BROWNS FERRY NUCLEAR PLANT (BFN) – UNITS 1, 2, AND 3 - TECHNICAL SPECIFICATION (TS) CHANGES TS-431 AND TS-418 – EXTENDED POWER UPRATE (EPU) – SUPPLEMENTAL RESPONSE TO ROUND 19 REQUEST FOR ADDITIONAL INFORMATION (RAI) AND RESPONSE TO ROUNDS 20 AND 21 RAI (TAC NOS. MD5262, MD5263, AND MD5264)

TENNESSEE VALLEY AUTHORITY BROWNS FERRY NUCLEAR PLANT (BFN) UNITS 1, 2, AND 3

TECHNICAL SPECIFICATIONS (TS) CHANGES TS-431 AND TS-418 EXTENDED POWER UPRATE (EPU)

SUPPLEMENTAL RESPONSE TO ROUND 19 REQUEST FOR ADDITIONAL INFORMATION (RAI) AND RESPONSES TO ROUND 20 AND ROUND 21 RAI

Figure EMCB.198-1b: BFN2 EIC Comparison

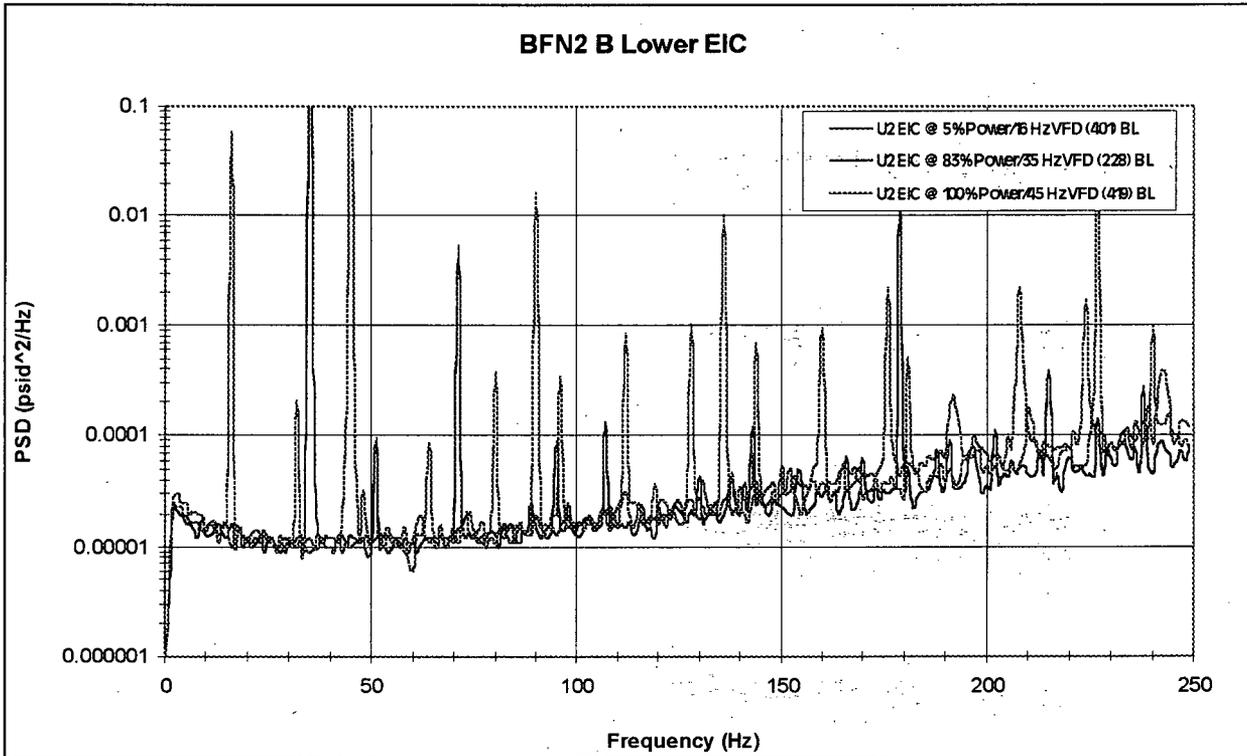
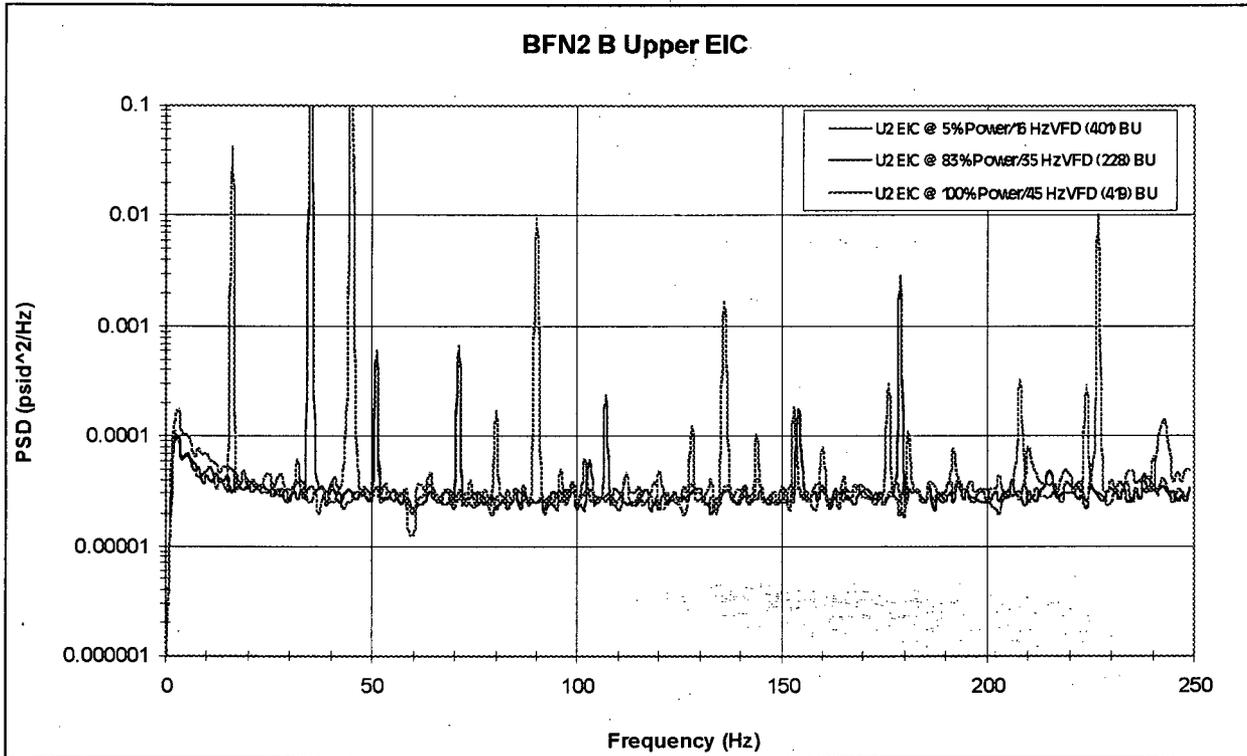
In the September 2, 2008 response for Unit 2 to EMCB-147, it appears that TVA subtracts the EIC signal from the low flow (LF) signal and treats the difference as mechanical noise (LF-EIC). Then it appears that TVA subtracts the EIC signal and the mechanical noise from the CLTP signal. The resulting signal is the acoustic pressure signal. Explain whether the EIC signal subtracted from the LF signal is the same as the one subtracted from the CLTP signal. If so, please provide justification. Note that in Figures EMCB.147-1a to 147-1d, the power spectral density (psd) for the 19 percent flow rate, in the high frequency range, is higher than that for 30 percent flow rate, which implies that the EIC noise is higher at lower pump/fan speeds.

Figures EMCB.155-1a through 1d provide comparison of three different EIC signals for each MSL strain gage array except for MSL D Lower. Strain gage failures on MSL D Lower prevent the acquisition of data for this array. Only mean filtering (0 - 2 Hz) and filtering of alternating current (AC) line noise at 60, 120, 180, and 240 Hz were applied in these plots; VFD frequency filtering was not performed in order to illustrate the associated VFD frequency peaks. These EIC signals consist of:

As can be seen in the comparison plots, the EIC signals at varying power and VFD operating frequencies vary more than the corresponding EIC signals for Unit 1 (see the response to RAI EMCB.198 in this submittal). This is likely caused by the additional noise that exists due to the close proximity of the MSL strain gage electrical penetration to the recirculation pump power cable penetration. Therefore, for Unit 2, it is necessary to obtain EIC signals at the same time that the corresponding CLTP or LF signal is obtained since EIC signals taken at different times are not the same and would not cancel out in the operation $[(CLTP-EIC)-(LF-EIC)]$.
